**Comments on the
Environmental Screening Report
for the
North Bala Falls Small Hydro Project

Technical Report**

On behalf of SaveTheBalaFalls.com, we submit these comments on the environmental screening report on the proposed north Bala small hydro project.

Figure 1 – Portaging Between Lake Muskoka and the Moon River

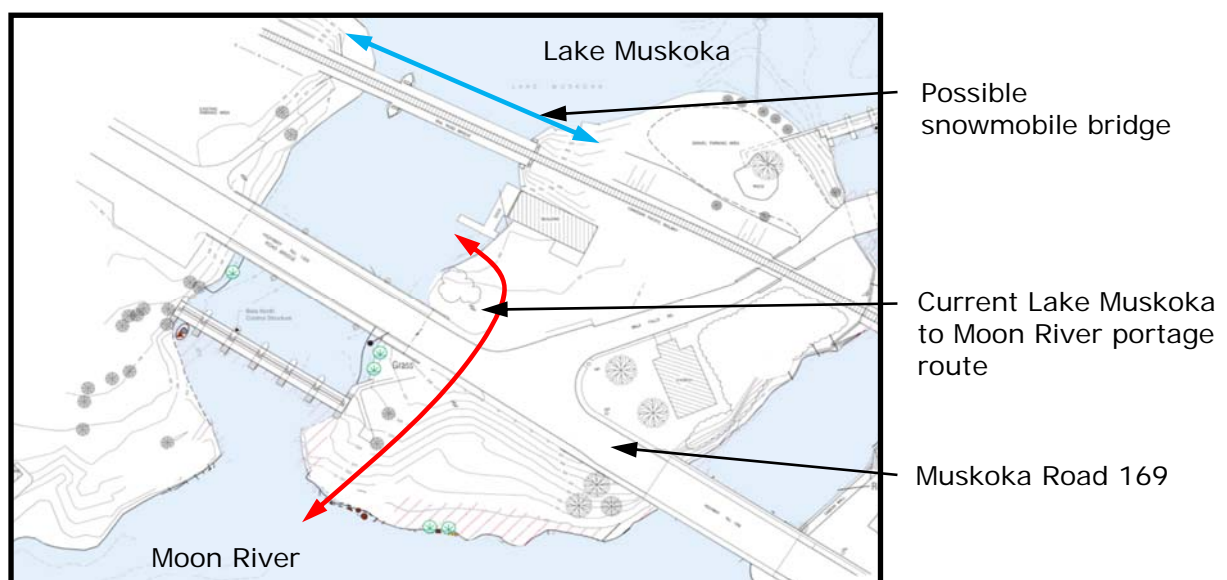
- 3) Strangely, as a third alternative, the proponent then offers that someday there may be a bridge built for snowmobiles (the location is shown in the Figure 1, below).

- a) The bridge doesn't exist and there are no budget or plans for such a bridge (though it has been discussed for years).
- b) Even so, the purpose of the bridge would be to get across the north channel. It would connect the town docks to Diver's Point, which are both on Lake Muskoka.

Figure 3 – Rendering Deficiencies

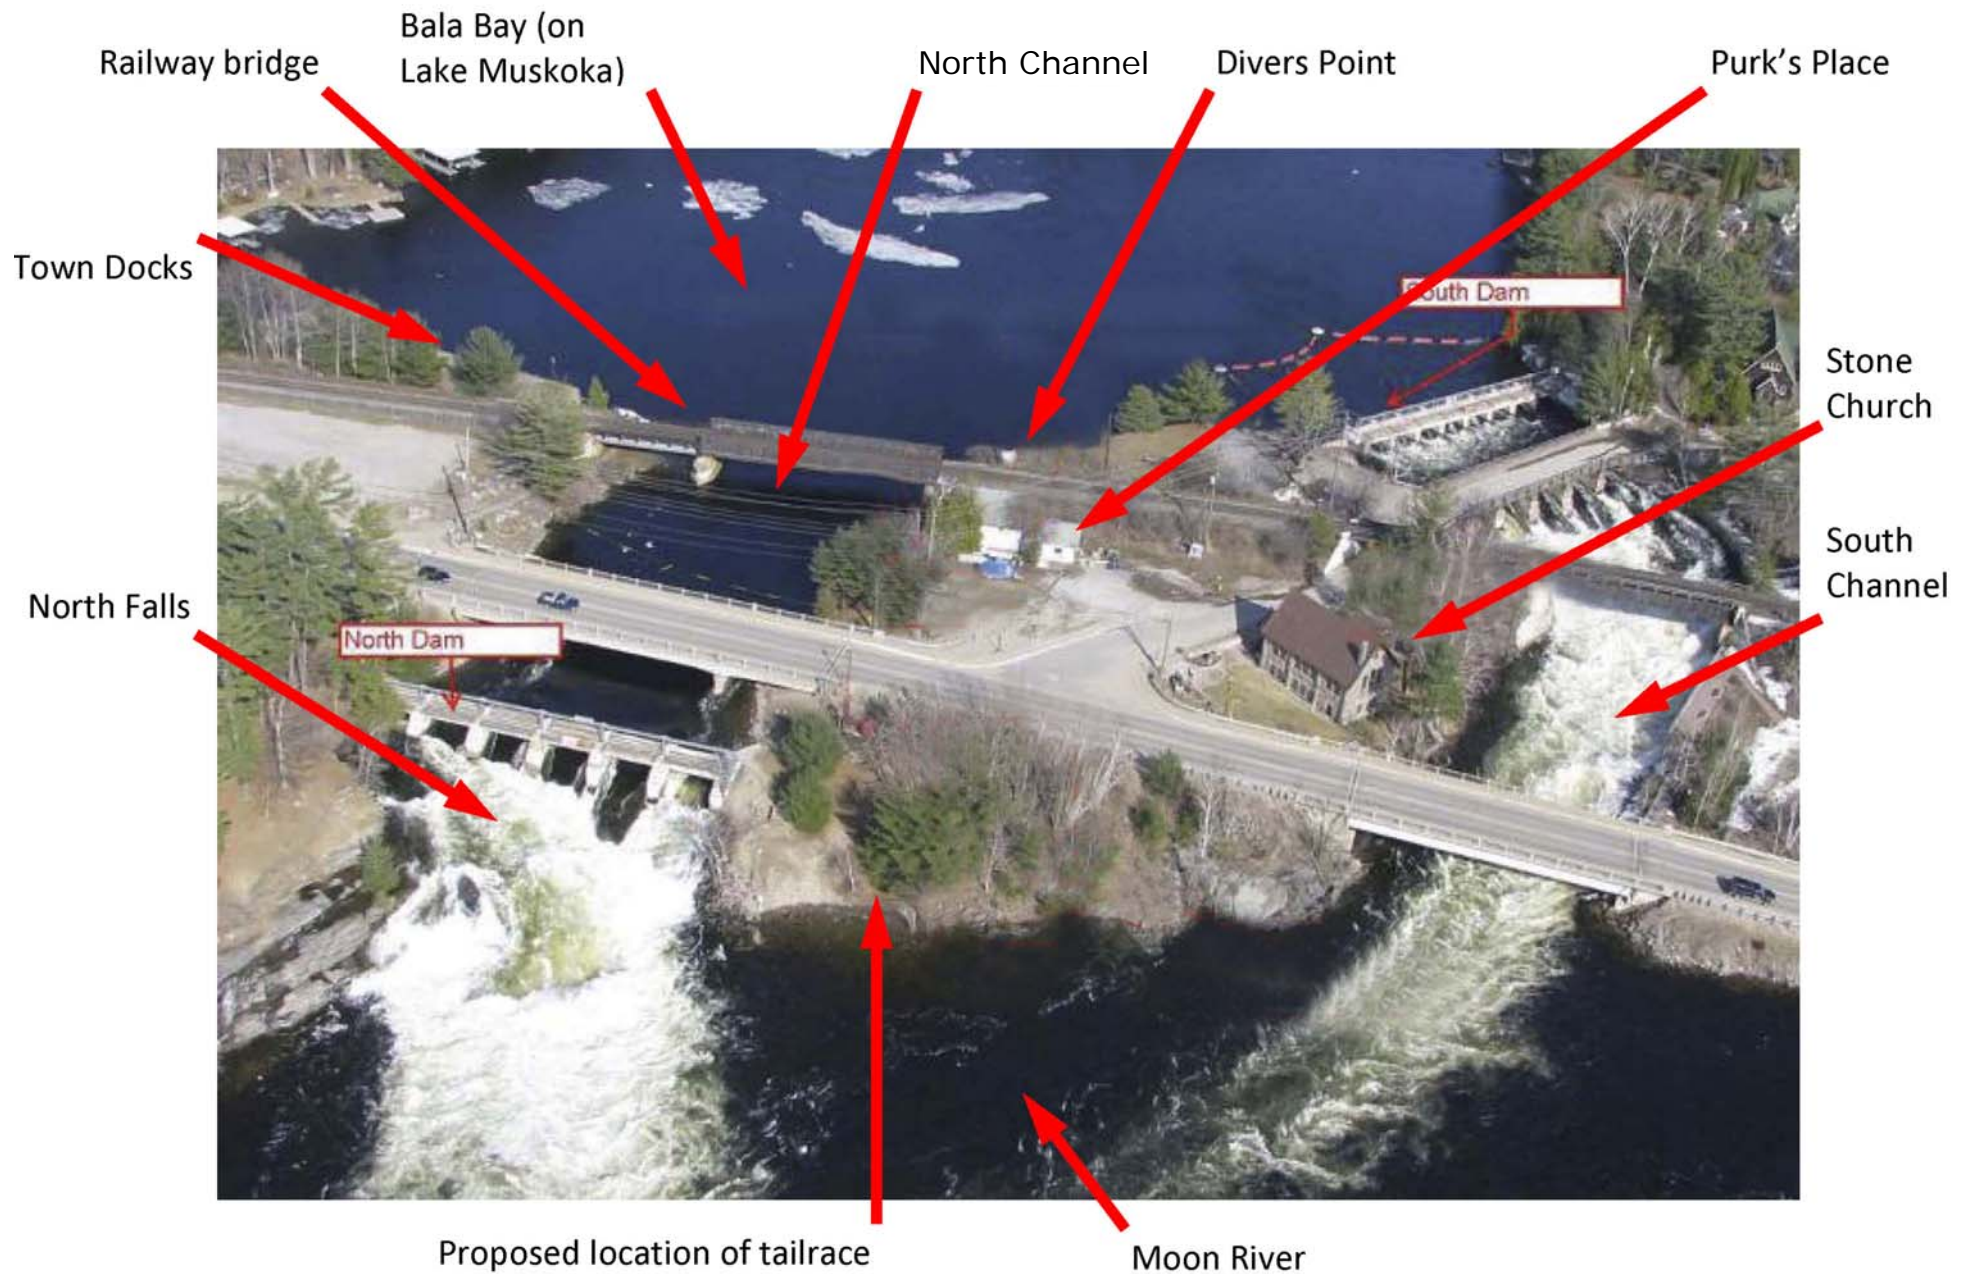
■ **We have requested this from the proponent for over a year.** Figure 3, below details some of the deficiencies of the proponent's Figure 6.6.

- a) A correctly-scaled drawing of the structure, as the rendering in Figure 6.6 is grossly distorted.
- b) The entrance door and whether it would be a typical single-person door, or would be a larger garage-type door.

- j) Drains will be required for the roof, and the piping to discharge this to the river need to be shown.
- k) Where the intake gates would be stored when not used for plant dewatering (these are mentioned in Section 1.5.1.2).

- p) Telecommunication lines, power lines (as used for powering plant machinery), and any other above-grade utility services, along with any exterior demarcation, disconnect, or metering enclosures.

- t) The cover hatches and any method needed to keep them water-tight, and the hoist mechanism needed to remove these when service access is required.
